ADDENDUM NO.: 1 **IFB or RFP NO.:** 664

Description: Furnish, Deliver and Install

Haworth Product

Project: CUNY in the Heights **Bid Opening Date**: 2/20/20

2ND FLOOR

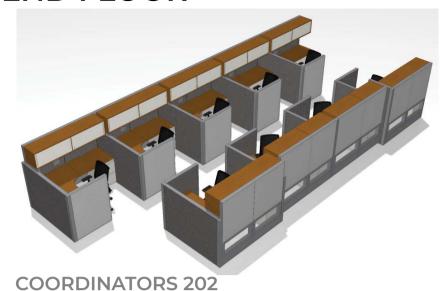
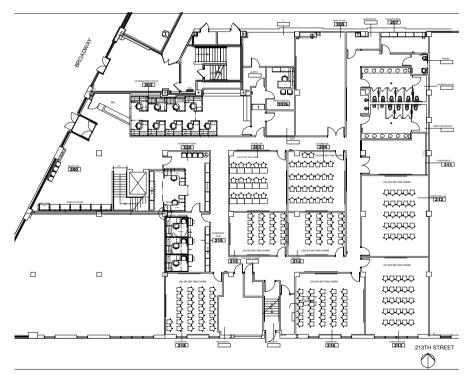
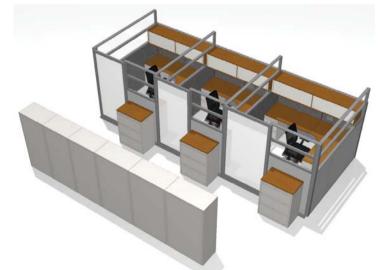
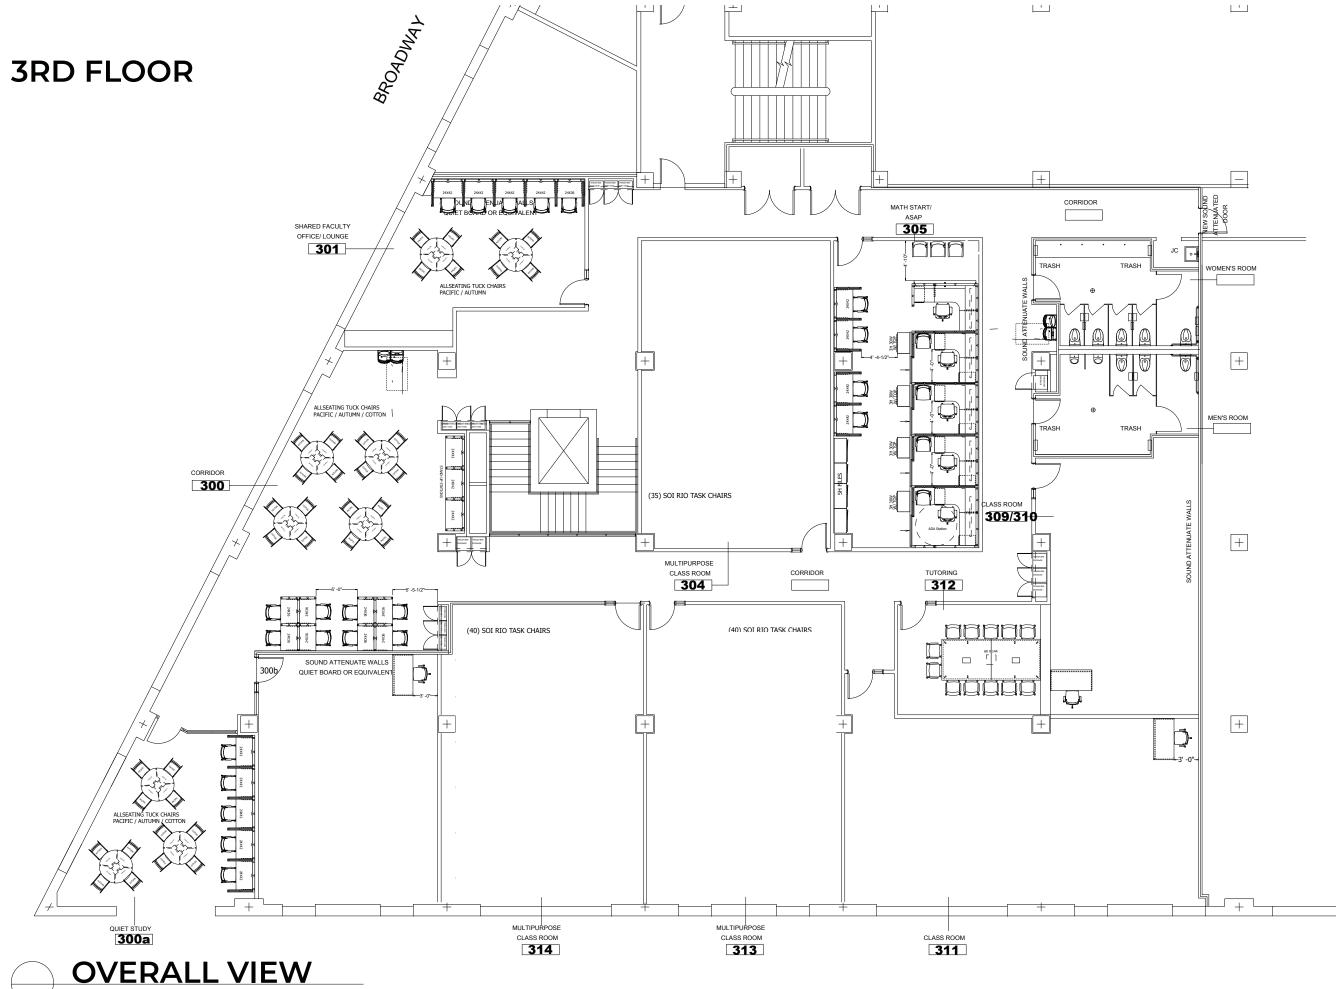
- 2. Scope of Work Changes have been made to the following sections:
 - 4. Scope and Summary of Work Language has been modified, as follows:
 - D. Perform installation work according to the 2nd and 3rd Floor drawings, as provided. Bidder must furnish all labor, special tools, supervision and services to complete the installation.

- a. Layout for Floors 2 and 3 are attached.
- b. Language has been modified to the following sections of the Site Logistics:
